A1 Birtley to Coal House

Scheme Number: TR010031

Applicant's Responses to ExA's First Written Questions – Appendix 1.7.D - Photograph of Noise Barrier

Version	Date	Status of Version
Rev 0	25 February 2020	For Issue

Figure 1 - Photograph of Noise Barrier

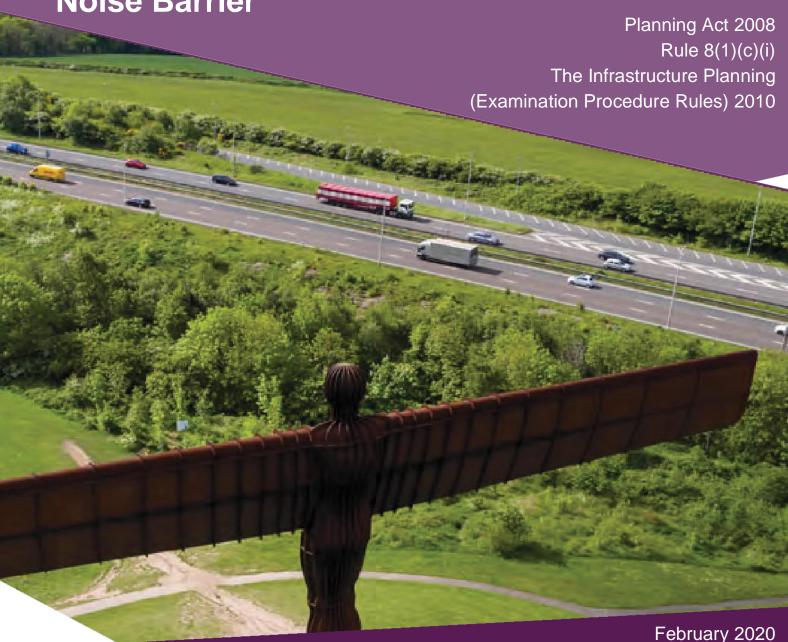
1.1.1 Figure 1 of this appendix supports the authors response to Written Question 1.7.11 of further details of the design and appearance of the noise barrier, and Figure 11.7a Noise Barrier – Birtley Barrier of the ES [APP-083] to include a photograph of a Noise Barrier. Other Harm is addressed by paragraphs 5.4.11 to 5.4.16 of the Planning Statement [APP-171]. Assuming that this section on "other harm" should be broadened to include all environmental effects in addition to landscape and visual effects then this section can be supplemented with information in the Environmental Statement [APP-037] which provides a summary of likely significant effects all environmental effects generated by the Scheme.
